Tillbridge Solar Project
EN010142

Volume 6
Environmental Statement Addendum
Document Reference: EN010142/APP/6.6

September 2024
Revision Number: 00

FIGURE NUMBER
Figure 1

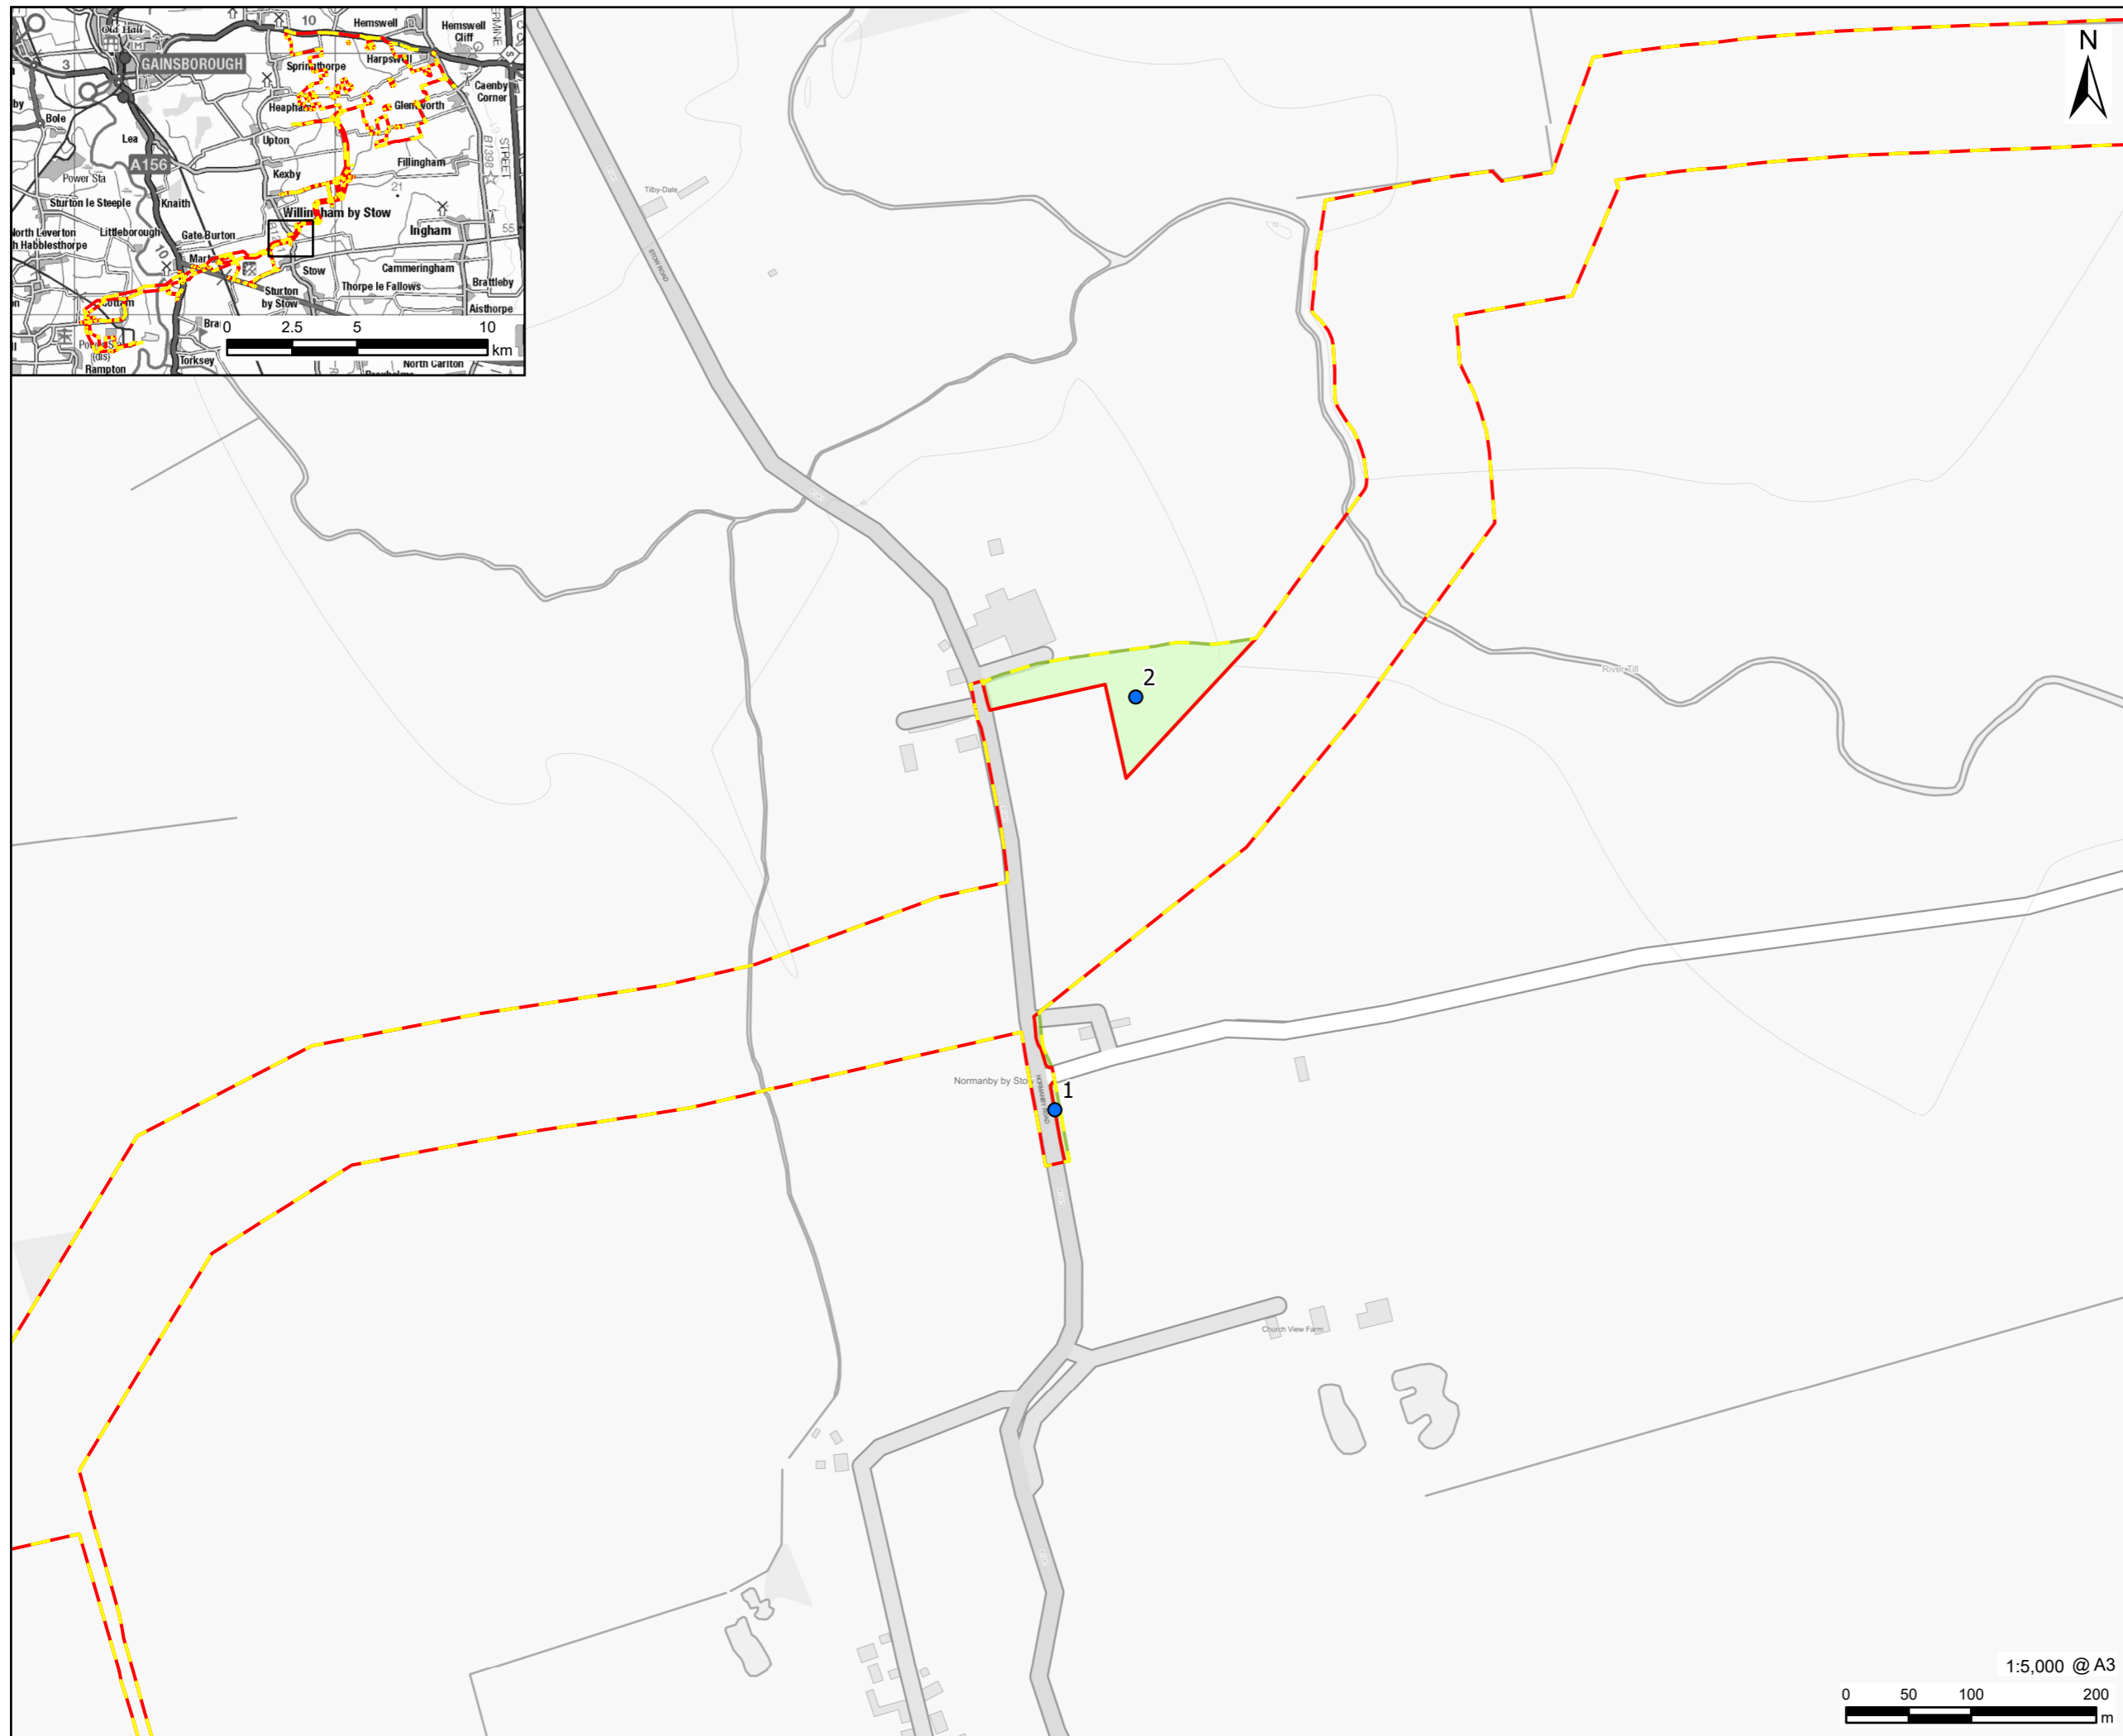
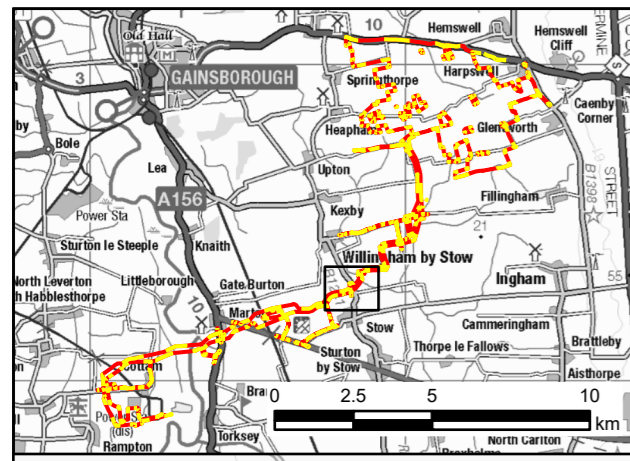
2.1.1 The Proposed Changes comprise the following, as shown on **Figure 1**:

FIGURE NUMBER
Figure 2

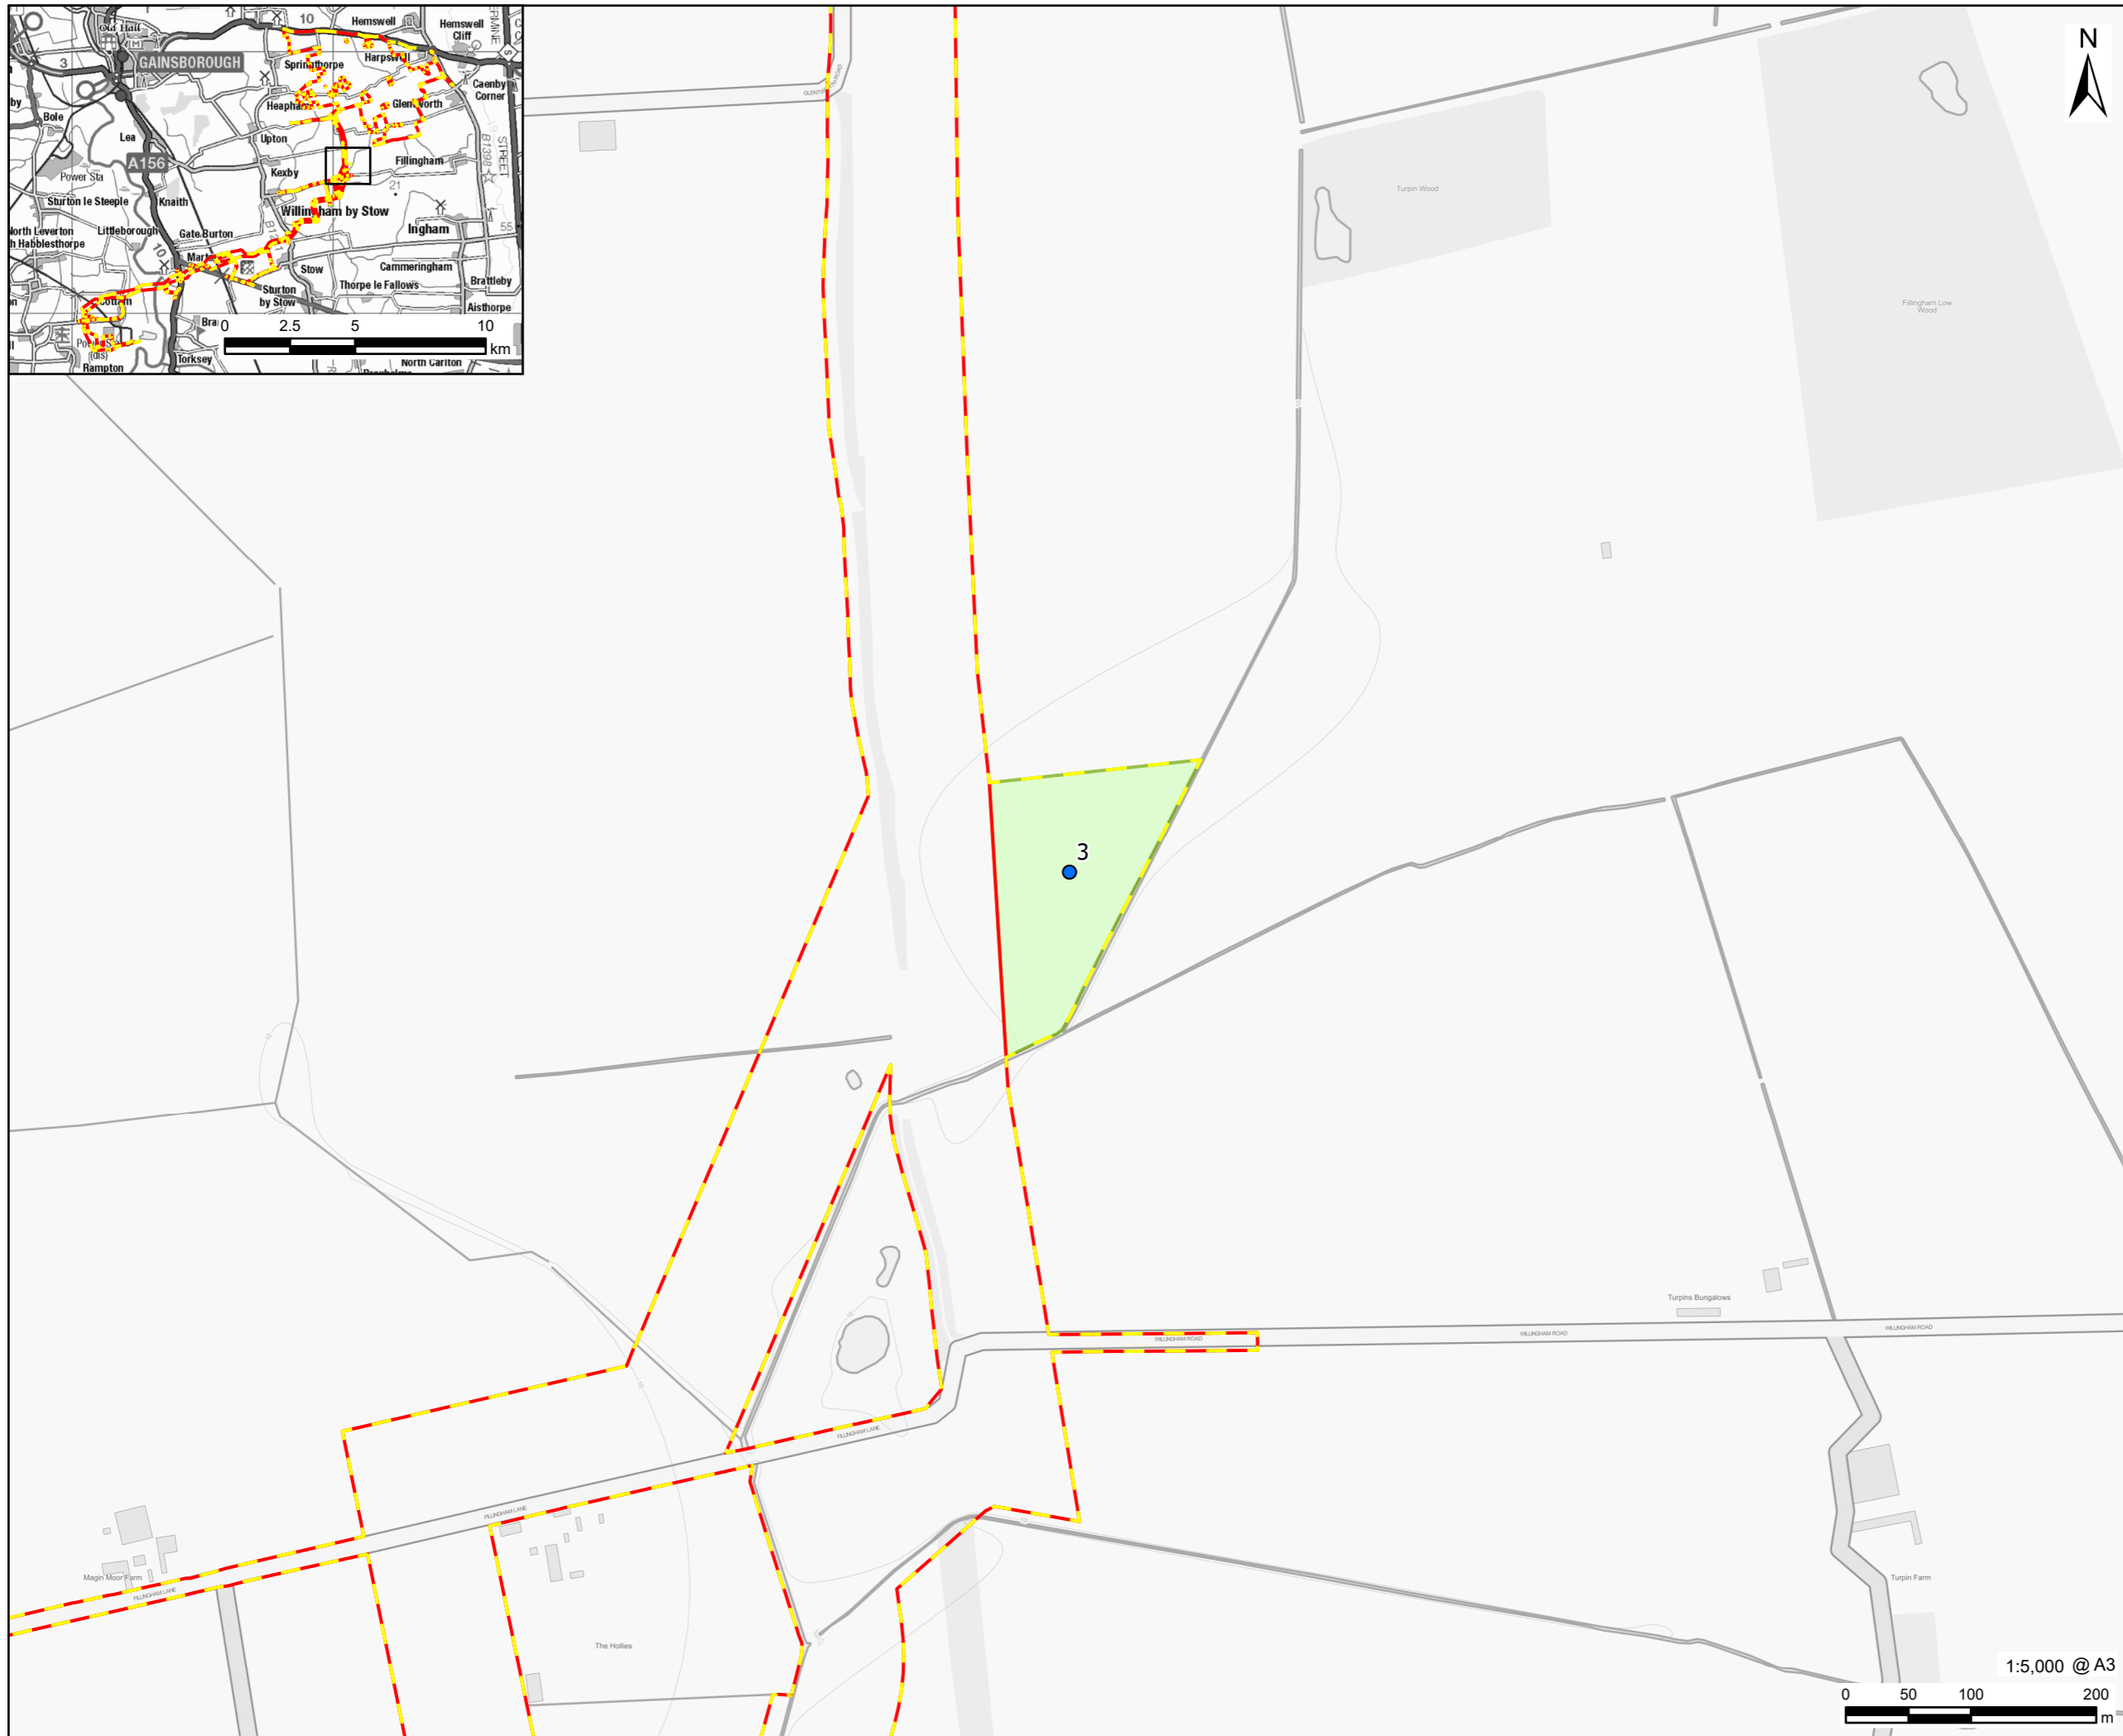
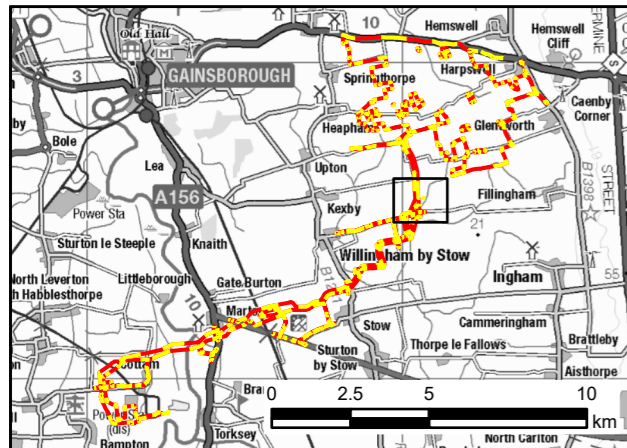
- 2.1.3 The change (see **Figure 2: Change 1 & 2**) is sought to refine the Order limits at this location so that it only includes public highway extents and does not involve third party land interests.
- 2.1.4 This change will result in a reduction to the Order limits but will not impact on the nature or extent of the works proposed to be carried out at this location. No new land interests will be engaged through this change, as no additional land outside the current Order limits is required.

- 2.1.5 Through further refinement of the Scheme layout and design, the Applicant has determined that a reduced area of land is required for the siting of a construction compound to the east of the B1241 Normanby Road. Plot 16-01a as shown on the **Land and Crown Land Plans [EN010142/APP/2.2(Rev01)]** has been reduced and modified as part of the change (see **Figure 2: Change 1 & 2**).
- 2.1.6 This change will result in alterations to the Order limits and a reduction in the area of land included within the Order limits.
